## Introduction

This errata sheet provides updated information on enhanced configuration devices—EPC4, EPC8, and EPC16—which are used to configure SRAM-based programmable logic devices (PLDs). This document addresses known issues and includes methods to work around the issues.

Figure 1. Configuration Example using EPC Device in FPP Mode Note (1)

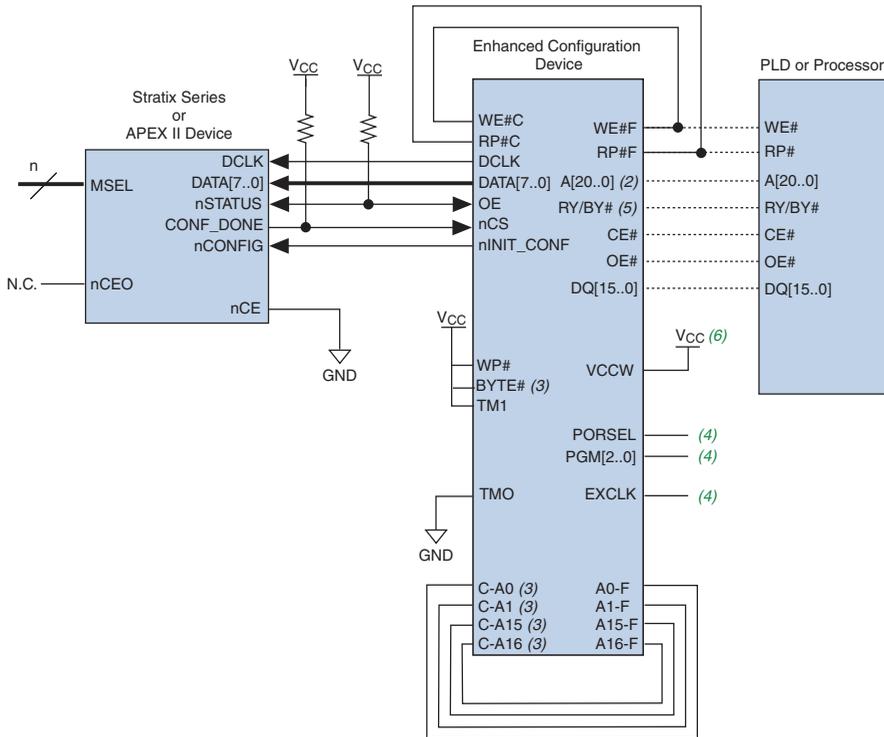
The  $RP\#$  pin is not internally connected to the controller. Therefore, an external loop-back connection between  $C-RP\#$  and  $F-RP\#$  must be made on the board even when you are not using the external flash interface. When using the external flash interface, connect the external device to the  $RP\#$  pin with the loop back. Tri-state  $RP\#$  at all times when the flash is not in use.

- (1) For external flash interface support in EPC8 enhanced configuration device, contact Altera Applications.
- (2) Pin A20 in EPC16 devices, pins A20 and A19 in EPC8 devices, and pins A20, A19, and A18 in EPC4 devices should be left floating. These pins should not be connected to any signal; they are no-connect pins.

- (3) In the 100-pin PQFP package, you must externally connect the following pins: C-A0 to F-A0, C-A1 to F-A1, C-A15 to F-A15, C-A16 to F-A16, and  $\text{BYTE}\#$  to  $V_{CC}$ . Additionally, you must make the following pin connections in both 100-pin PQFP and 88-pin Ultra FineLine BGA packages: C-RP# to F-RP#, C-WE# to F-WE#, TM1 to  $V_{CC}$ , TMO to GND, and WP# to  $V_{CC}$ .

- (6) To protect Intel Flash based EPC devices content, you have to isolate the  $V_{CCW}$  supply from  $V_{CC}$ .

**Figure 2. DATA and DCLK Signals Generated by Enhanced Configuration Devices**

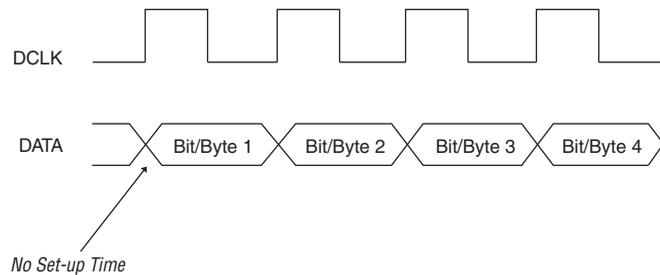
The problem is due to a set-up time violation of the DATA signal. The enhanced configuration device generates the DATA and DCLK signals so that they arrive at the PLD simultaneously.

The PLD requires a set-up time of 10 ns. However, since the DCLK and DATA signals transition simultaneously, the set-up time at the PLD is actually zero. [Figure 2](#) shows the DATA and DCLK signals generated by enhanced configuration devices.

**Figure 4. DATA Latches on Second Rising Edge of DCLK after DATA Path Delay**

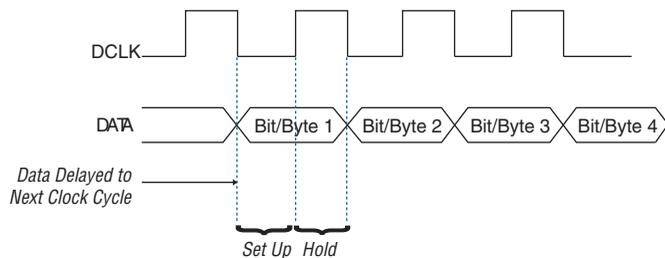
After inserting the delay, the `DATA` transition would shift to the right so that the first bit or byte of data would be latched on the second rising edge of `DCLK`, as shown in Figure 4. This shift meets the required set-up time for the `DATA` signal.
